Technical Committee on Fire Pumps (FIM-AAA)

SUBJECT: **AGENDA – NFPA 20 First Draft Meeting (Annual 2018)**

NFPA 20 First Draft Meeting (Annual 2018)

Figure A.7.5.1.6.1.1.1 lumped inertia definition

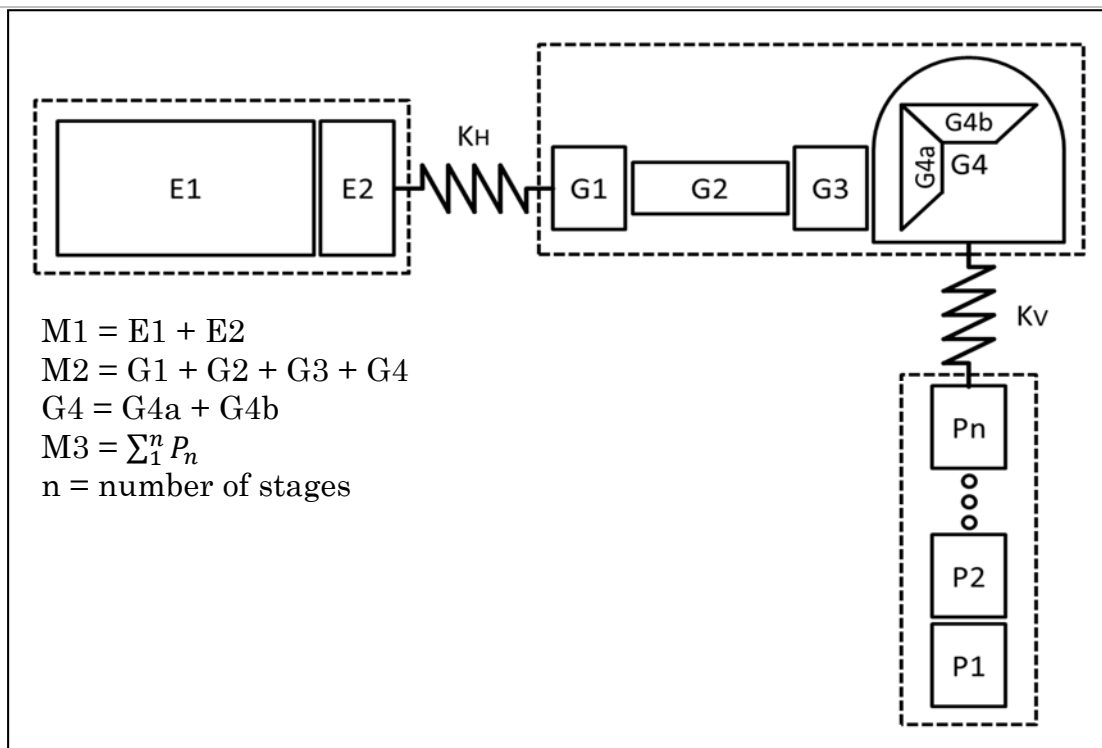
7.5.1.6.1.1 For drive systems that include a diesel engine, torsional coupling, right angle gear drive and vertical shaft pump, the pump manufacturer shall provide at minimum a 3-mass torsional frequency calculation indicating that the first two natural frequencies of the system and the critical speeds associated with engine firing frequency are found to at minimum be 25% above or 25% below when the pump is operating at rated speed.

7.5.1.6.1.1.1* The torsional frequency calculation specified in 7.5.1.6.1.1 shall include the mass elastic characteristics for a wetted pump with the specific impeller(s) trim, torsional coupling, right-angle gear, gear ratio, flexible connecting shaft, and the engine.

A.7.5.1.6.1.1.1 The system should be considered as three lumped inertias (M1, M2, M3) connected by two springs (KH, KV).

Summary, in the changes no requirements have been eliminated, however much additional guidance in the form of requirements and ANNEX material has been added to help package designers through the evaluation of mass elastic systems. Since the 2106 edition it has been learned that a 2 mass torsional analysis is not adequate for this type of system, therefore the requirement has change to a 3 mass torsional analysis with guidance as to how to elevate the analytical process for systems that result in marginal 3 mass calculations to determine if these systems can be predicted as reliable.

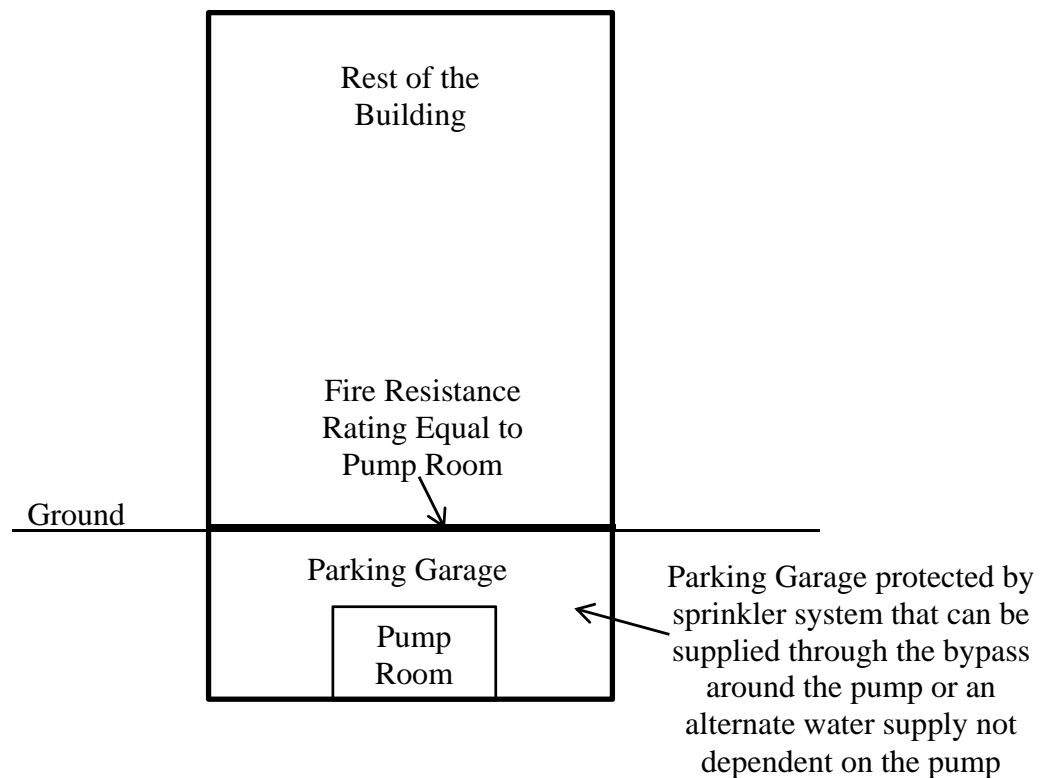
A.4.13.2.1.1.2 Figure A.4.13.2.1.1.2 shows the intent of the body of the standard. The parking garage in this building is separated from the rest of the building by a 2-hr fire resistive rating and the fire sprinkler system is capable of being supplied from the city main without the fire pump, so if a fire occurs in the parking garage, no personnel need to be sent to the pump room.

This is an explanation and figure to help understand the intent of the new paragraph that was submitted to the body of the standard to provide a reasonable exception to the rule for a protected path to the pump room while still protecting the person being sent to the pump room.

Figure A.14.2.6.5(d) Horsepower and Amperage Sample Curve -- Underperforming 1500 gpm at 105 psi Fire Pump.

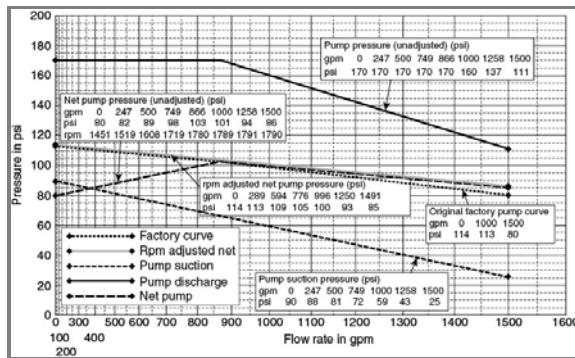
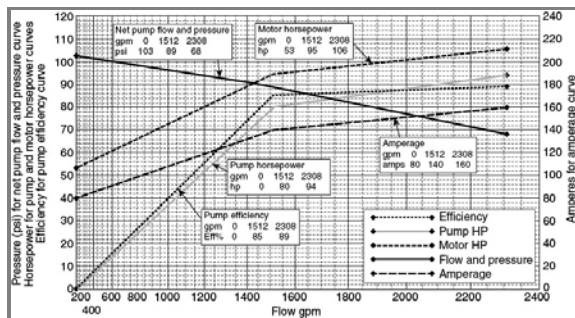
- (h) In general, a head-capacity curve [see [Figure A.14.2.6.5\(b\)](#) and [Figure A.14.2.6.5\(c\)](#)] and an ampere-capacity curve [see [Figure A.14.2.6.5\(d\)](#)] should be plotted. A study of these curves will show the performance picture of the pump as it was tested.
- (i) The final step of the evaluation is to document and notify the appropriate authorities of the fire pump status, which includes whether the fire pump passed or failed, if the fire pump was left in service, and any issues that were identified. Any outstanding issues should be addressed and a retest scheduled if necessary.
